[Docket No. FAA-2012-0060; Directorate Identifier 2012-NE-02-AD; Amendment 39-17123; AD 2012-14-09]

#### Airworthiness Directives; Pratt & Whitney (P&W) Division Turbofan Engines

**ACTION:** Final rule.

**Figure 1 to Paragraph (e) - Determination of Vane Eligibility**

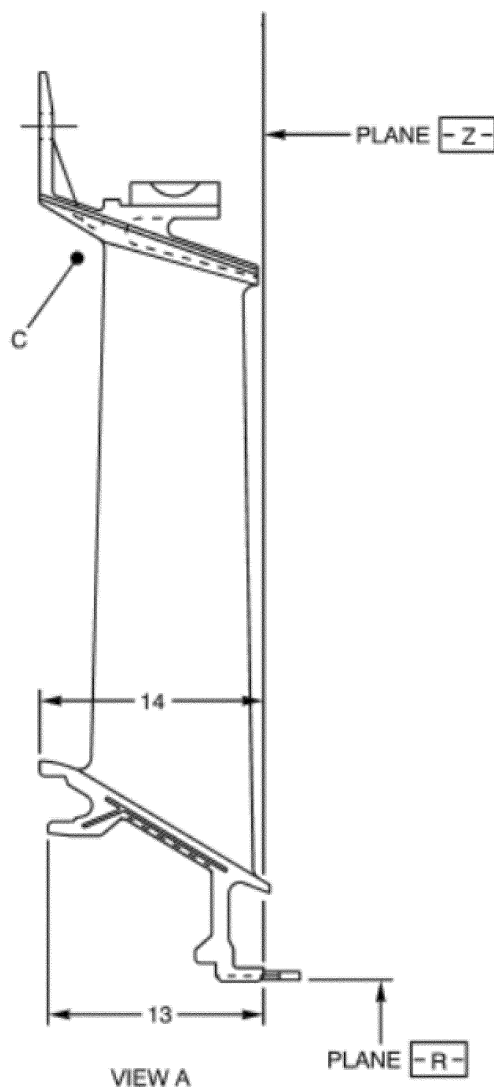
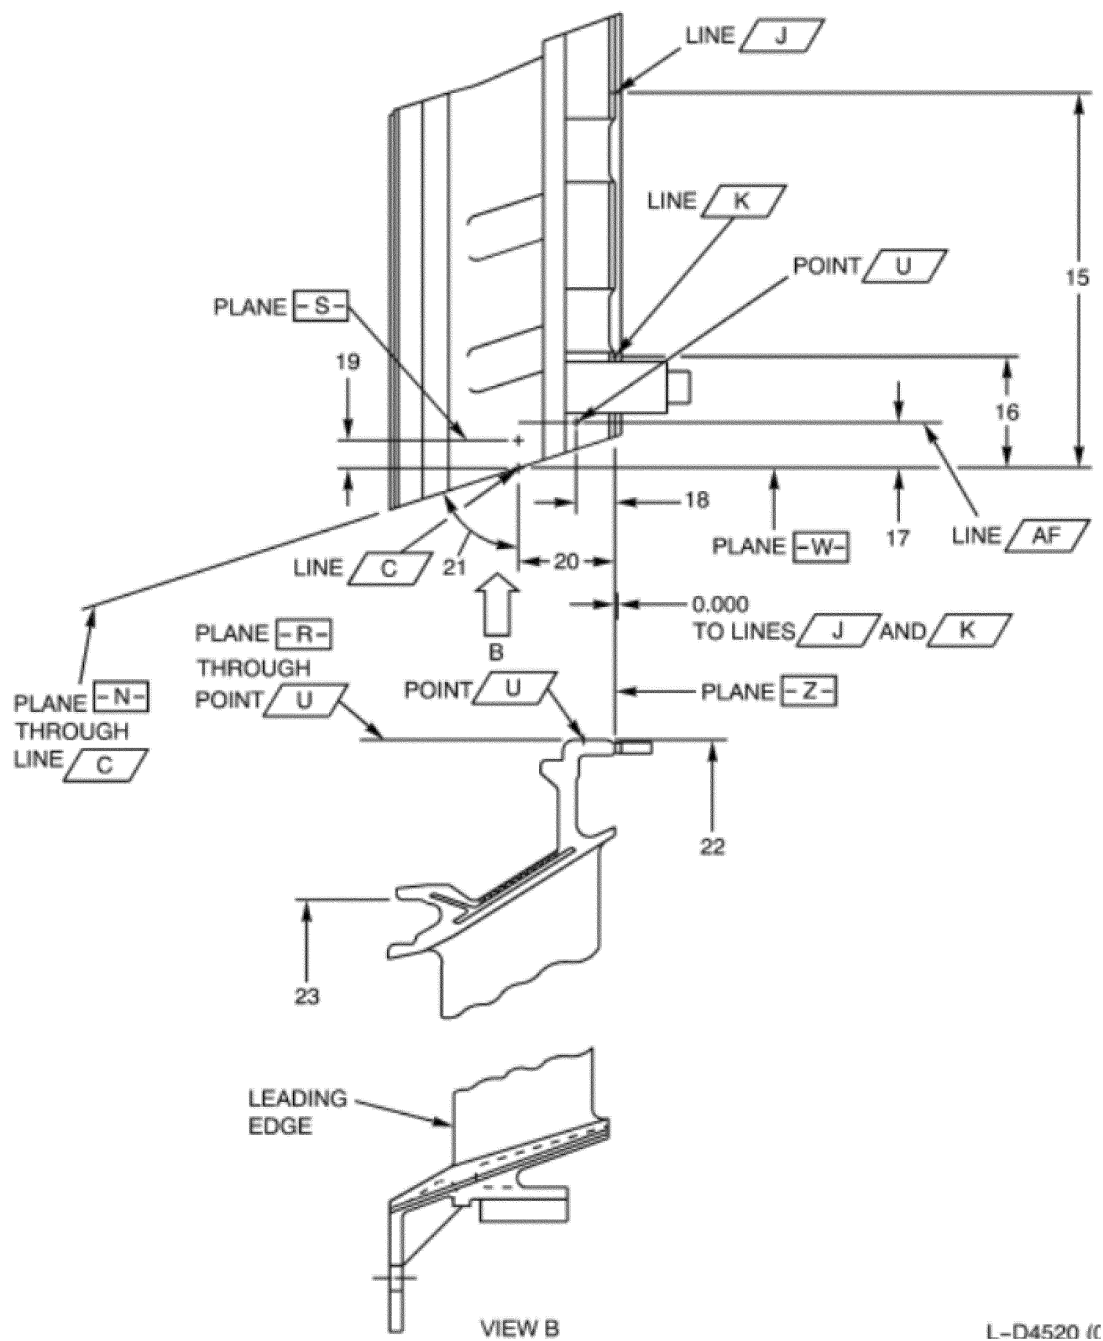
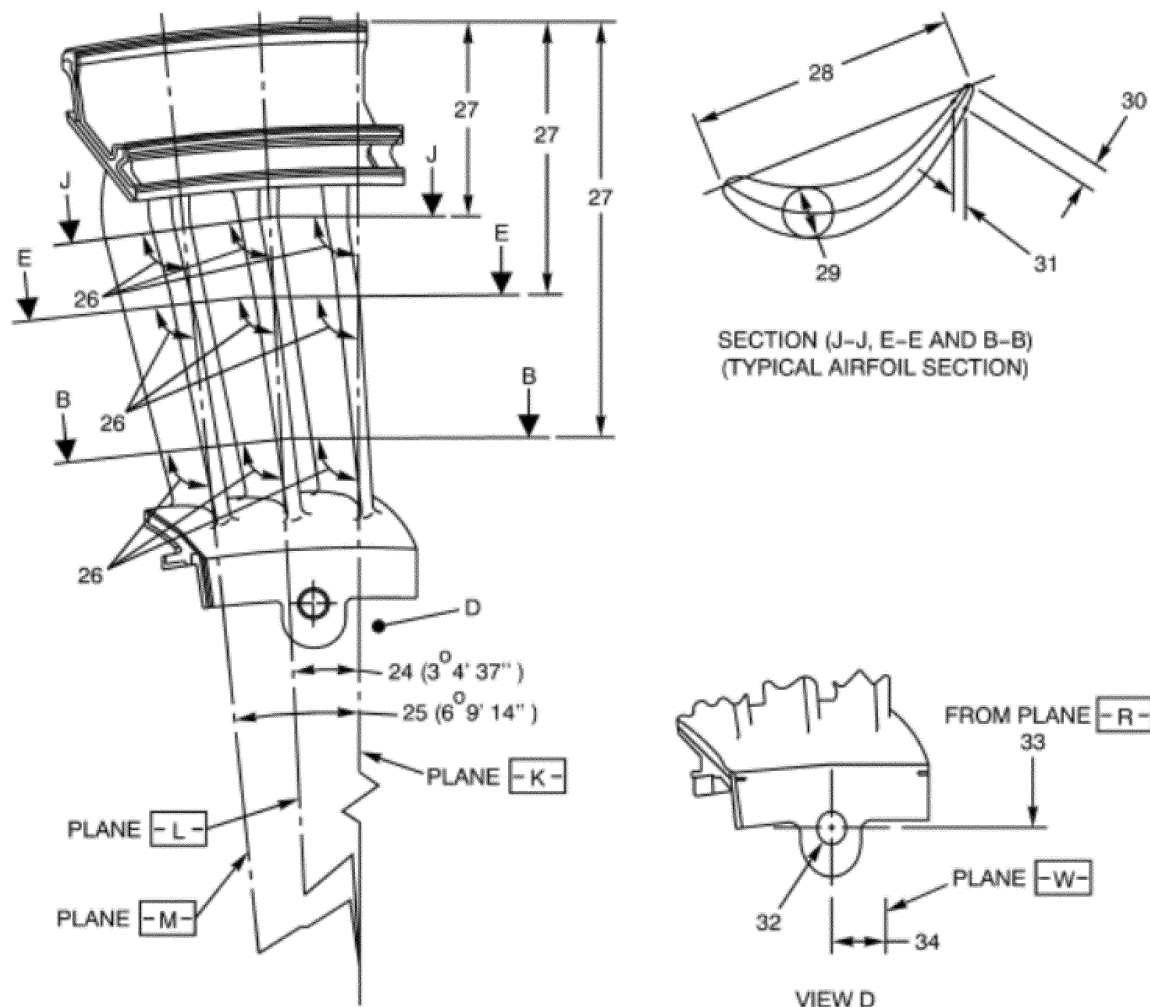
United Airlines requested that in proposed AD paragraphs (e)(1)(iii) and (e)(1)(iv), we change "ensure adequate engagement" to "dimensionally inspect the applicable LPT case slot serviceable dimensions and 3rd stage vane serviceable dimensions per the appropriate CIR." The commenter also requested that we list the specific dimensions to inspect by index number. The commenter stated that no mechanic can deduce what an adequate engagement is because it is not specific enough.

We agree. We changed paragraph (e)(1)(iii) to "dimensionally examine index 13 through index 34 of the LPT 3rd stage vane cluster assembly." We also changed paragraph (e)(1)(iv) to "dimensionally examine index 23 and index 24 of the vane engagement slots on the rear turbine case, where the 3rd stage vane is installed." We also listed the specific dimensions to inspect by index number, and included the supporting figures in this AD.

(iii) Dimensionally examine index 13 through index 34 of the LPT 3rd stage vane cluster assembly. Use Table 2 to paragraph (e) of this AD and Figure 1, Figure 2, and
